Subject: Response to Request for Additional Information  
Regarding the Increase in the  
Interim Plugging Criteria for  
Byron Unit 1 and Braidwood Unit 1  
NRC Docket Numbers: 50-454 and 50-456

Reference: D. Lynch letter to Commonwealth Edison Company  
dated August 24, 1995, transmitting  
Request for Additional Information

## NRC Request for Additional Information Number 6

Figure 61-1

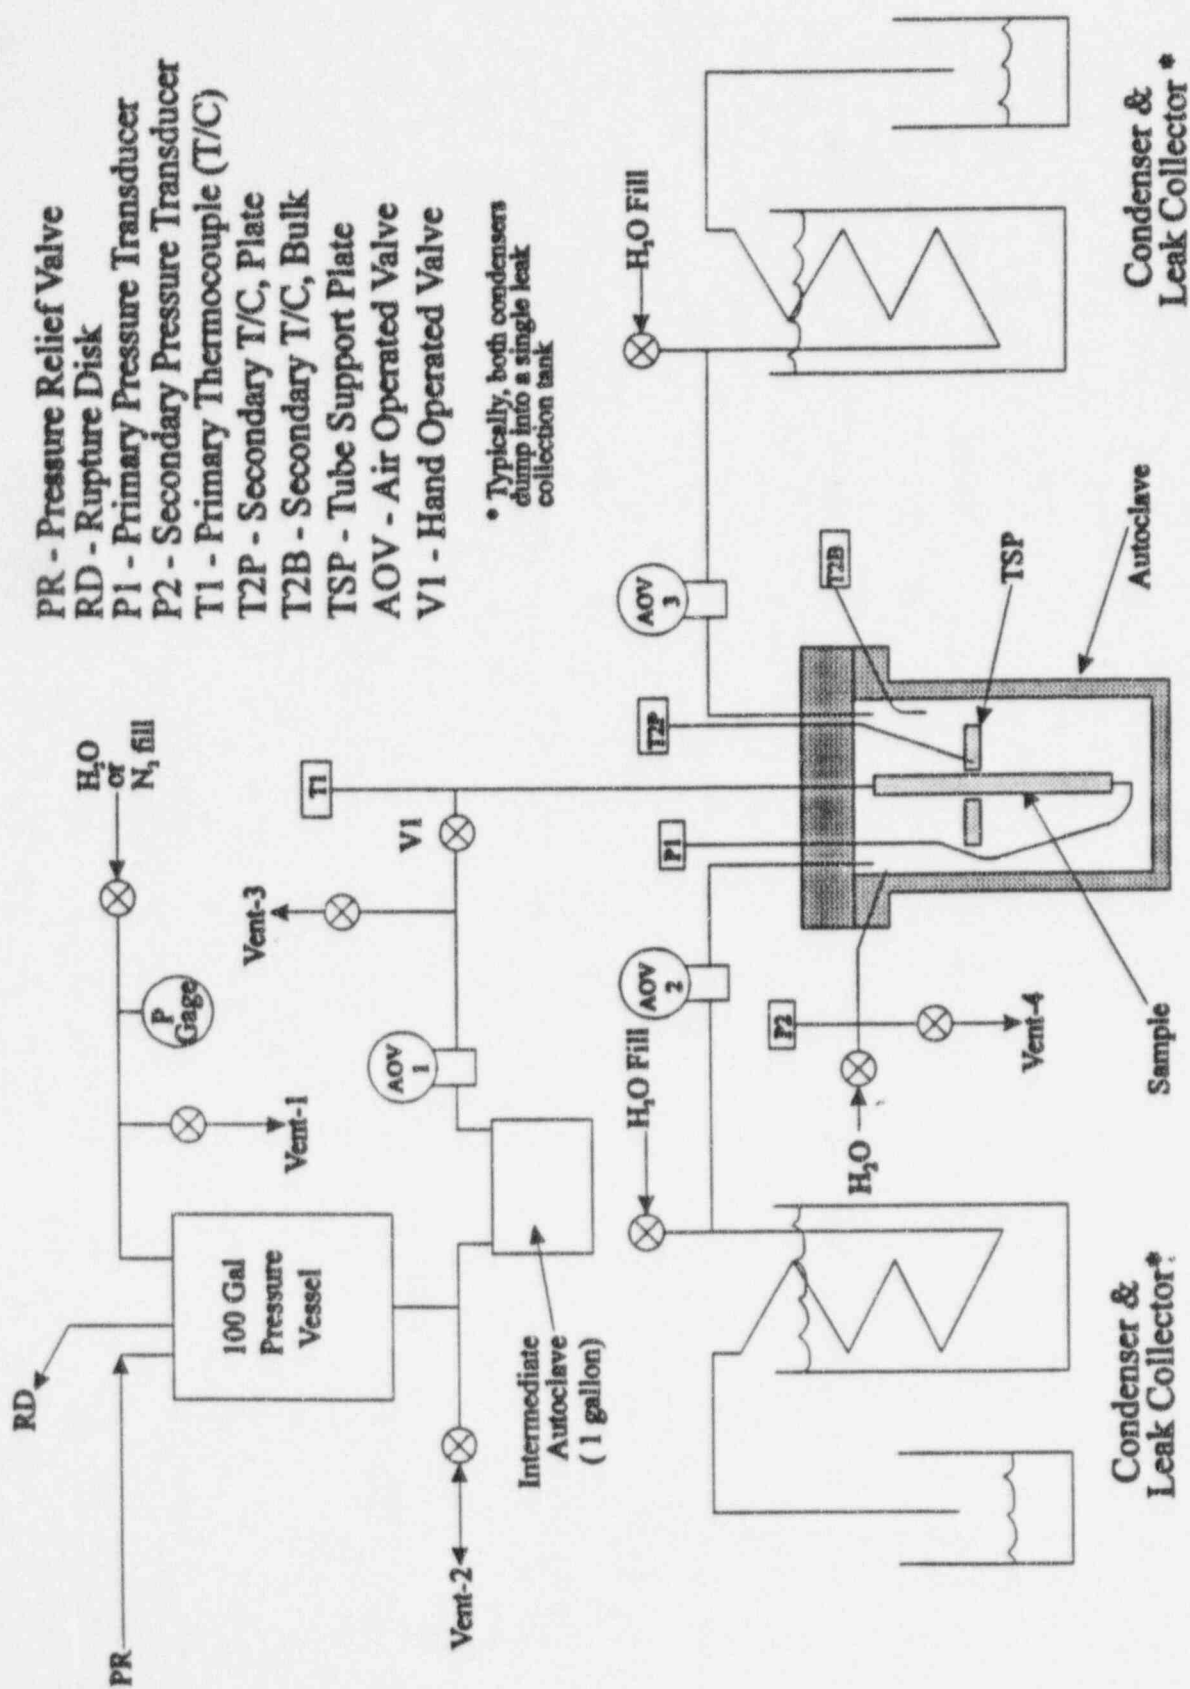
61. To quantify the uncertainty in the SG tube leakage measurements for an indication restricted from burst (IRB), the leakage from a set of orifices has been measured as part of your IRB test program. Discuss any modifications and/or repairs preformed on the test rig and/or facility since the original SG tube specimen IRB leak rate testing was performed. Discuss whether these modifications and/or repairs, if any, would alter your conclusions derived from the orifice testing. For example, if a valve in the test rig was leaking by the seat, the leakage from this valve could result in an underestimate of the leakage. If a leaking valve was replaced or repaired prior to the orifice testing, uncertainties in the leakage measurements may not be fully quantified.

Figure 61-1 is a schematic of the test rig that shows the connection among the source tank, shim autoclave, test autoclave, air operated dump valve and the condenser/accumulators. The test process was to establish the desired conditions in the source tank with the dump valve closed, opening the dump valve to vent the test autoclave to the condensers at atmospheric conditions, and collecting and measuring the condensed leakage volume in the accumulators. Thus, any repairs or modifications that could affect the leakage measurement would have to occur between the test autoclave and the accumulators. Only those repairs/ modifications that addressed a test rig condition that resulted in leakage to the atmosphere, downstream of the test autoclave, could have resulted in an error in the measured leak rate, since the measured test leak rate is a dynamic time differential of the accumulated volume with the internal system (source tank to condenser exit) wide open. Leaks upstream of the test autoclave, including the test autoclave head, would only have affected the test process (i.e. ability to establish desired conditions) and would not have affected the leak rate measurement. No tests were performed with any known leakage in the test rig, and no repairs/ modifications were made that could affect the leakage measurements.

The repairs/modifications performed on the hot leak test facility during the time of testing the original specimens (test sequence numbers 1 through 4) and completion of the additional tests (test sequence numbers 11 and 12, and calibrated orifice tests) are summarized below, and their effect on leak rate measurements is discussed:

1. A bypass valve was added to the test and shim autoclaves on the upstream (input) side to bypass the autoclaves in the event of a leak. No leaks were observed, and this valve was never utilized. No leakage through this valve was observed during subsequent testing.

2. Rupture disks were added to the shim and test autoclaves as protection against an overpressure event. The rupture disks had no effect on the testing.

3. The bulk secondary thermocouple was replaced. This repair had no effect on the testing.
4. A leak on the inlet line to the autoclave was repaired by cleaning the leaking connection. The repair was made prior to initiation of a test. Inlet line leaks do not effect the leakage measurement since the inlet conditions are measured at the test specimen, and the outlet (leakage) flow is condensed and collected.

5. The air operated valve on the condenser loop 2 was stuck open at the end of a test during sequence 11-2. Repairs were made prior to continuing any testing. No leakage through the air operated valves was observed after repairs to the valve were completed. Valve maintenance, consisting of lubricating the spring in the actuating mechanism, was performed prior to performing the calibrated orifice tests. The seating and sealing function of the valves was not affected.

The function of the air operated valves is to close the system until the desired primary conditions are established in the system, then to open the system to the condensers at atmospheric pressure so that leakage through the test specimen occurs. Leakage through either valve would have prevented establishing loop equilibrium prior to venting to the condensers, and would have been observed as an increase in the condensed leakage volume prior to initiating the test. The increase volume in the accumulators would not have affected the leak rate measurements since these are made as a dynamic time differential of the accumulated volume during the test with the system wide open.
